UNITED STATES PATENT AND TRADEMARK OFFICE

APPLICATION NO.	FILING DATE	FIRST NAMED INVENTOR	ATTORNEY DOCKET NO.	CONFIRMATION NO.
10/754,876	01/09/2004	Ronald A. Trumble	SLTRUM.00002	8670

Office Action Summary	Application No.	Applicant(s)	
	10/754,876	TRUMBLE ET AL.	
	Examiner	Art Unit	
	Alvin A. Hunter	3711

DETAILED ACTION

Fig. 3

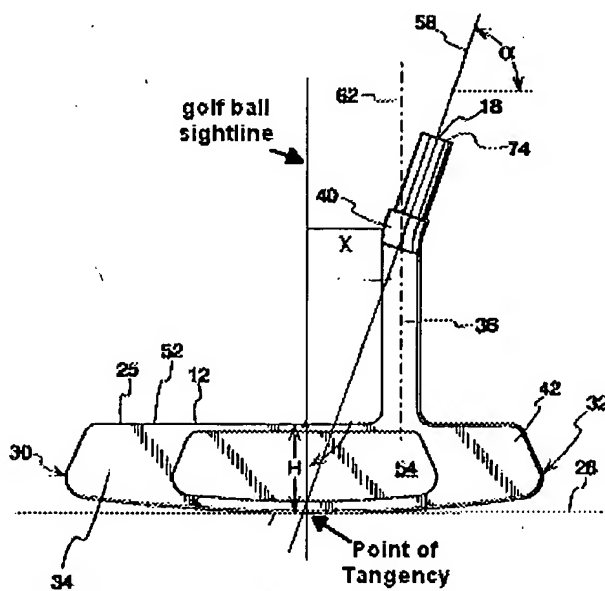
Regarding claim 1, Pinns shows a golf club having a shaft **14** for holding the putter, a putter head **12** affixed to a terminal end of the shaft, vertical leg **38**, horizontal leg **40**, and a stub shaft **18** wherein elements **38**, **40**, and **18** make up a shaft attachment means at the end of the putter head for receiving the terminal end of the shaft wherein a centerline extends through the center of the shaft and continues through

a center portion of the stub shaft (See Figures 4 and 5). Pinns does not explicitly disclose the shaft attachment means being a hosel. Klein discloses a golf putter having a hosel for connecting the shaft to the putter head (See Figures 4 and 5 and paragraph bridging columns 4 and 5). The hosel of Klien has a stub at the end thereof and is recognized to be a hosel; therefore, it is submitted that Pinns inherently shows a hosel for receiving a shaft.
